Subject: Phase V Activation Field Change
Southeast County Landfill, Hillsborough County, Florida

**RE: Modification #35435-003 to existing operation permit
Permit No.: SO29-256427, Hillsborough County
Southeast County Class I Landfill**

Subject: Additional Information to Florida Department of Environmental Protection regarding the Southeast County Landfill (SCLF), Phases V and VI Operations Modification, Pending No. 35435-003, Hillsborough County, Florida

Figure 1. Berm Breach Repair Plan.

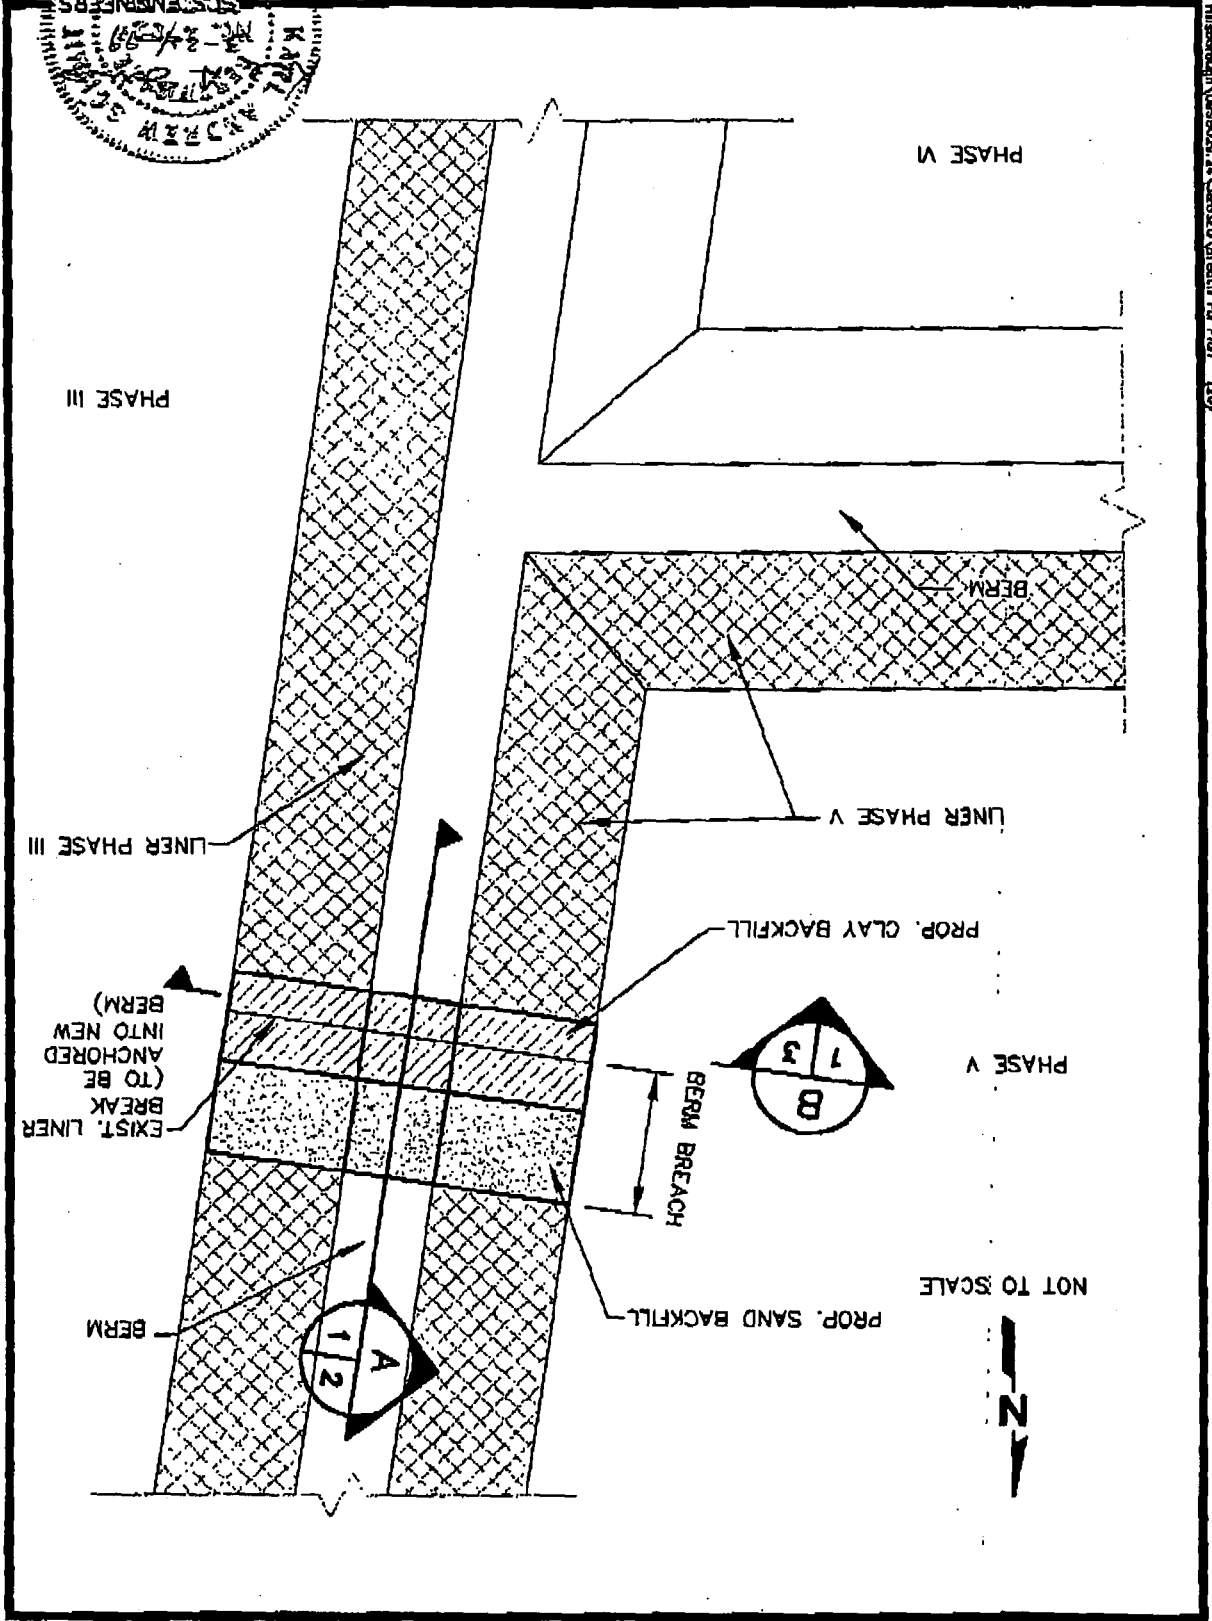
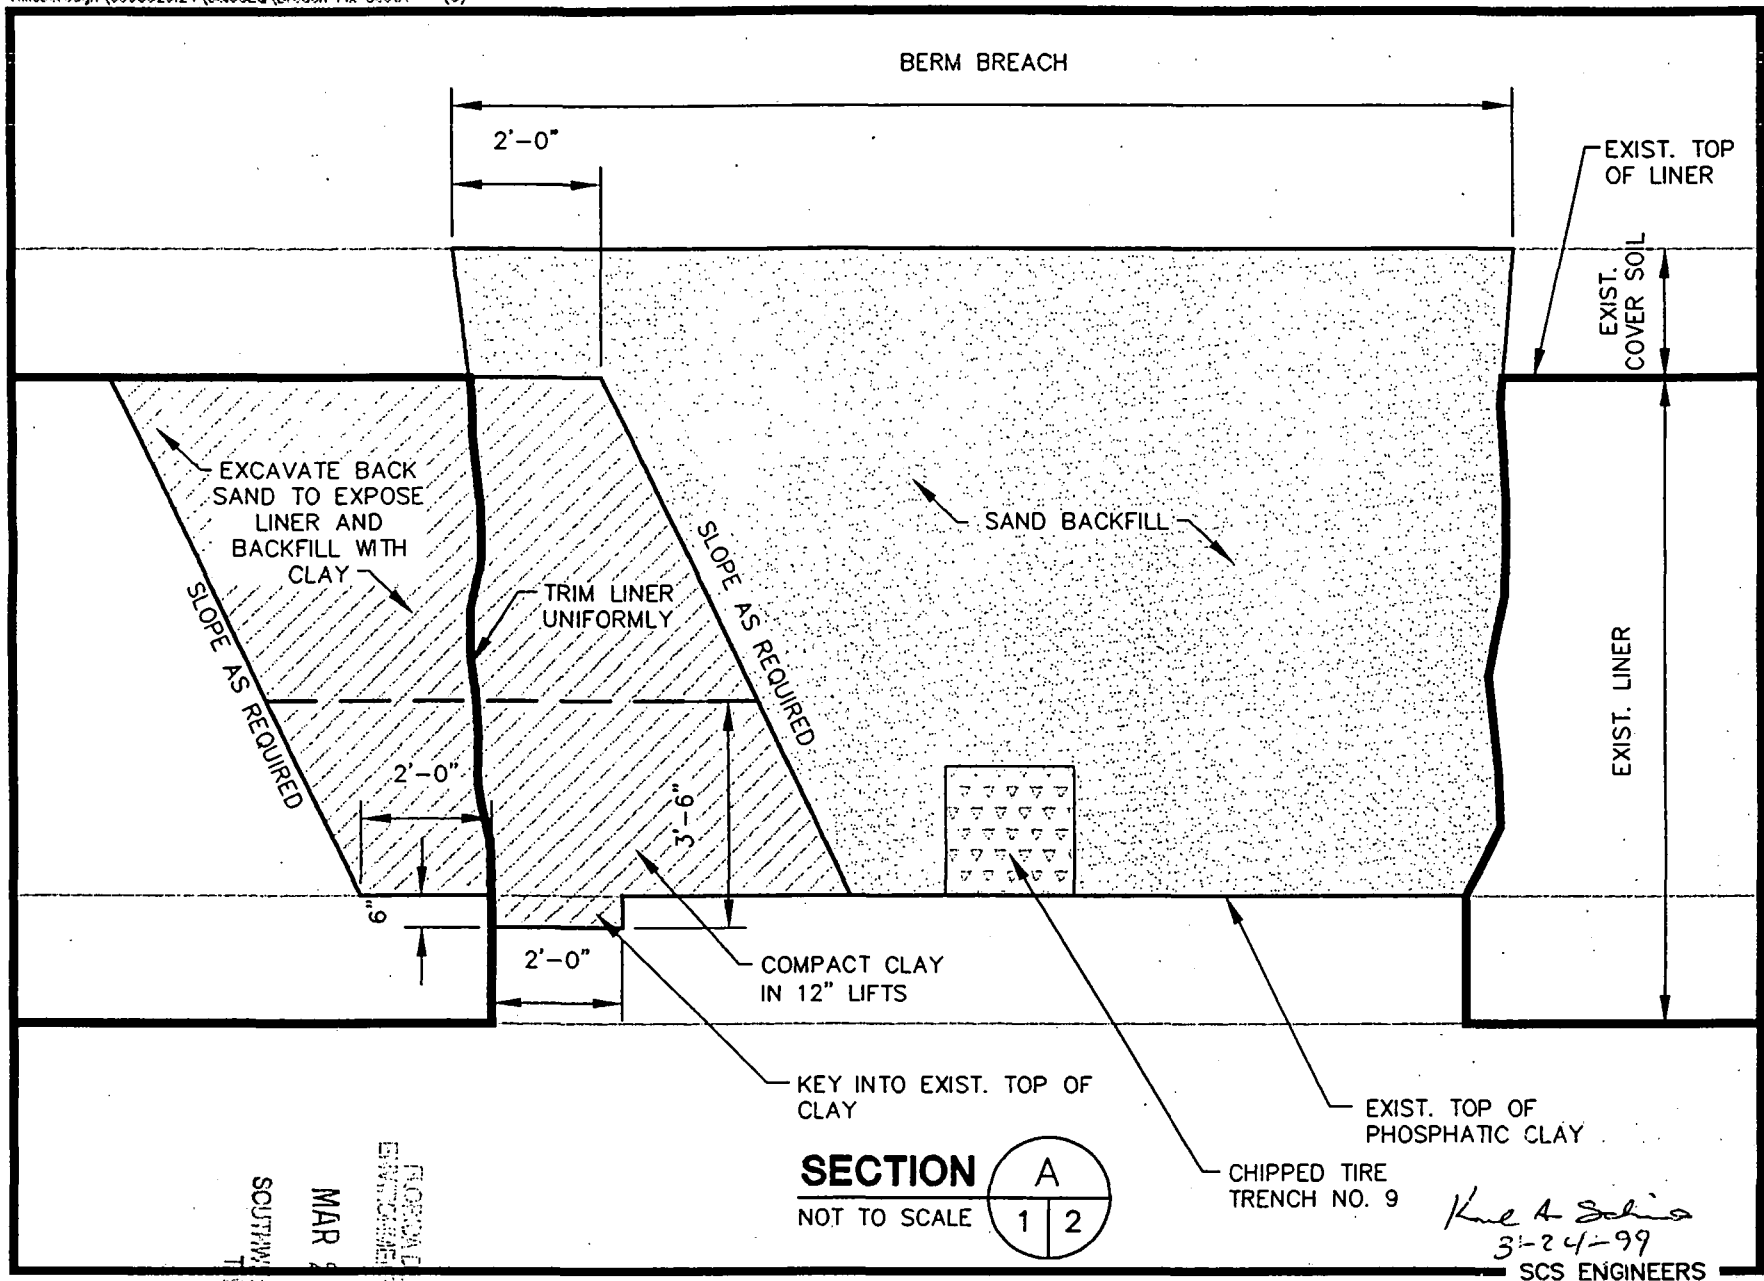
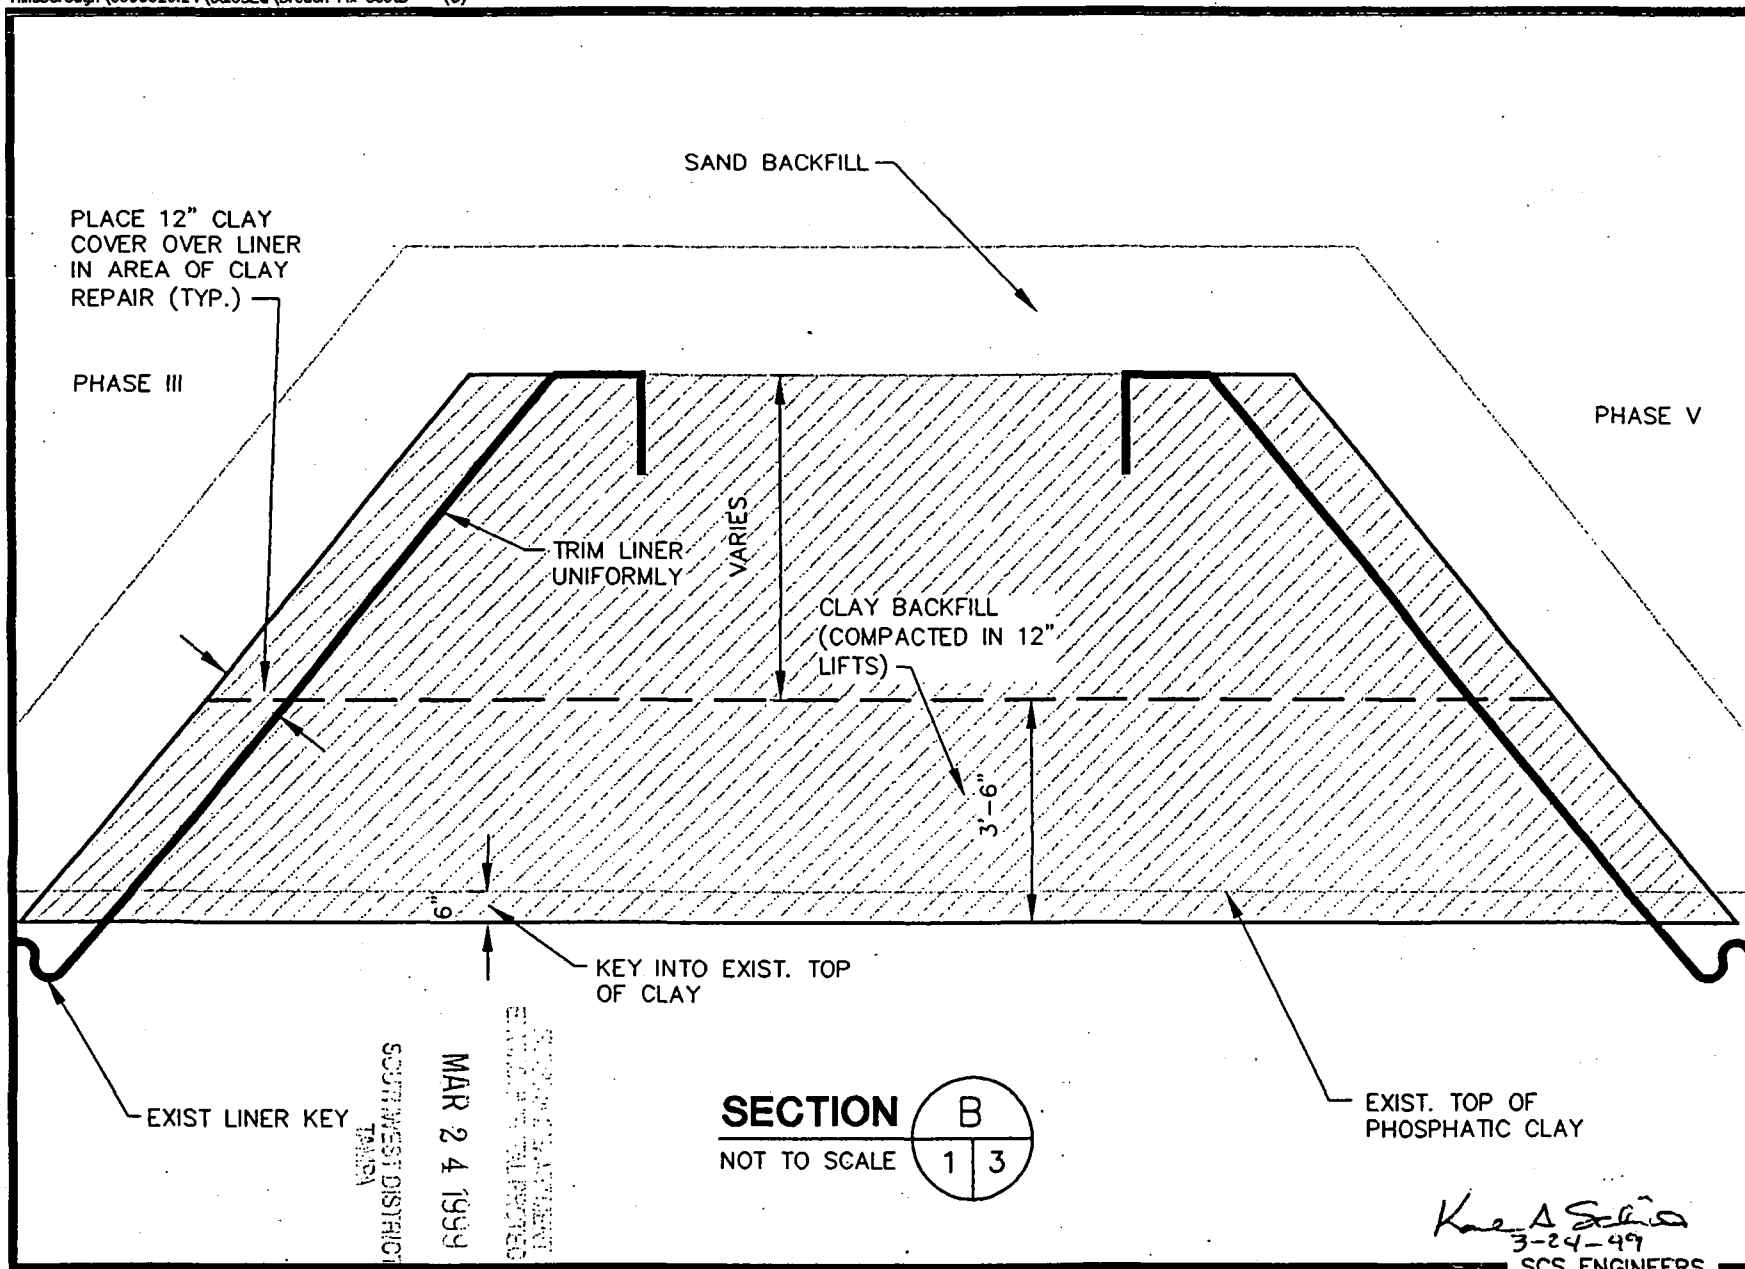
SE LINER BEING REPAIR

OK - SUBJECT TO FOLLOWING:

① MAX PERMEABILITY OF CLAY 1×10^{-5} cm/sec,
